TECHNICAL SERVICE BULLETIN

MODELS: MAXJAX M6 AND M6K

SUBJECT: HYDRAULIC FITTING REPLACEMENT

The Hydraulic Elbow Fitting looks like this:

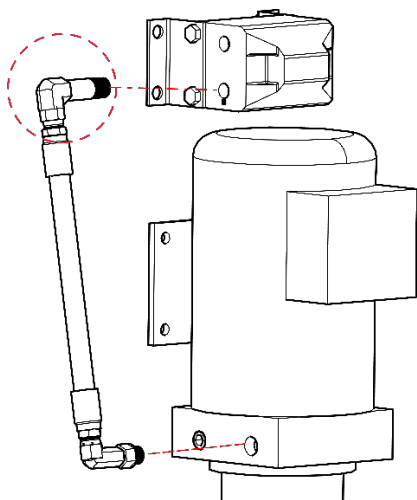
The container that comes with this TSB includes a Hydraulic Elbow Fitting (**FTG ELB 3/8" JIC MALE x 3/8" NPTF MALE, LONG**) that replaces the Hydraulic Elbow Fitting that came in the Parts Bag of your Lift. The Hydraulic Elbow Fitting connects to the Flow Divider.

Note: The two Hydraulic Elbow Fittings look *very* similar; be careful to not mix them up. The only difference is the hole on the NPT end is slightly bigger on the Hydraulic Elbow Fitting that comes with this TSB.

Discard the Hydraulic Elbow Fitting in the Parts Bag that came with your Lift. Instead, use the Hydraulic Elbow Fitting that comes with this TSB.
